Re: South Fork Quitcupah 2R2S Amendment, Canyon Fuel Company, LLC, SUFCO Mine C/041/0002

**Title:** South Fork Quitcupah 2R2S

**Modification of the Monitoring & Mitigation plan for the South Fork Quitcupah 2R2S panel. Need approval by December 30, 2011.**

Figure 7-9  
 South Fork Quitchupah Monitoring Locations

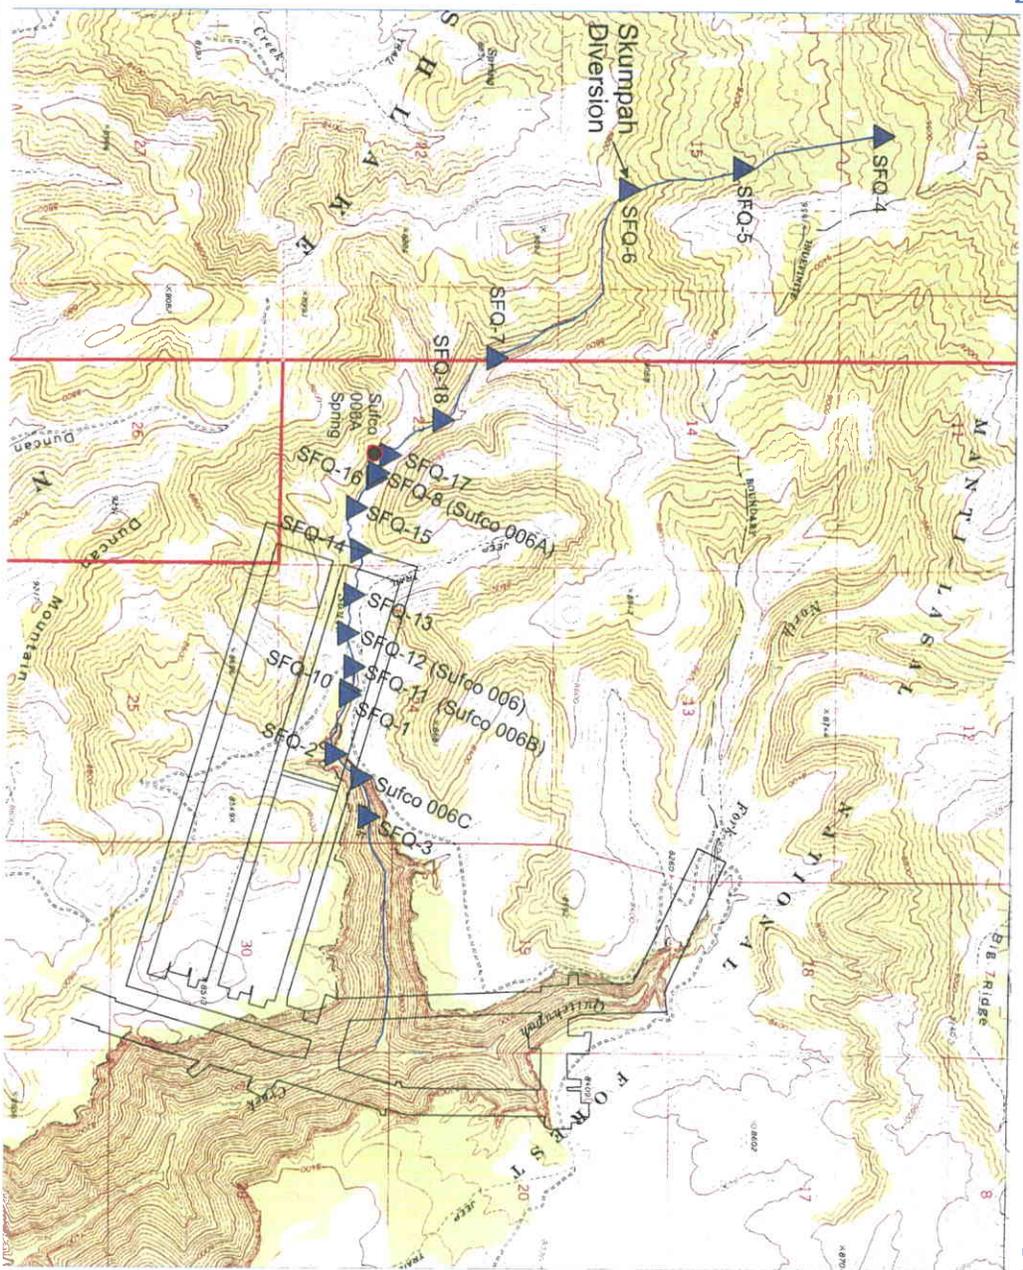
Prior to the initiation of undermining and subsidence, a pre-subsidence survey of the stream channel will be conducted in the portion of South Fork of Quitchupah that flows over the 2R2S panel and associated gate roads. The survey will consist of a gain/loss survey of flow within the stream channel paying particular attention to surface flows and ground water discharge, soil conditions, and the general channel geomorphology. A similar study was performed in the past but all stream measurements were not conducted on the same date. The second gain/loss survey will be completed on a single day at or near base flow conditions late in the summer or early fall of 2011. The mine will attempt, as part of this second survey, to occupy the same monitoring sites in the panel area as those chosen in the initial survey.

Two weeks before and then once every two weeks after subsidence mining begins, the measuring locations occupied during the gain/loss survey will be reoccupied and flow measurements of the stream flow will be obtained. The approximate locations of these sites are illustrated on Figure 7-9. The once every other week flow measurements will be supplemented by visual observations of flow performed twice a week or once every three to four days. Flow/no flow conditions will be described on these days. If no flow or diminished flows are noted, the appropriate mine and Forest personnel will be contacted and the mitigation plan to restore flows will be implemented.
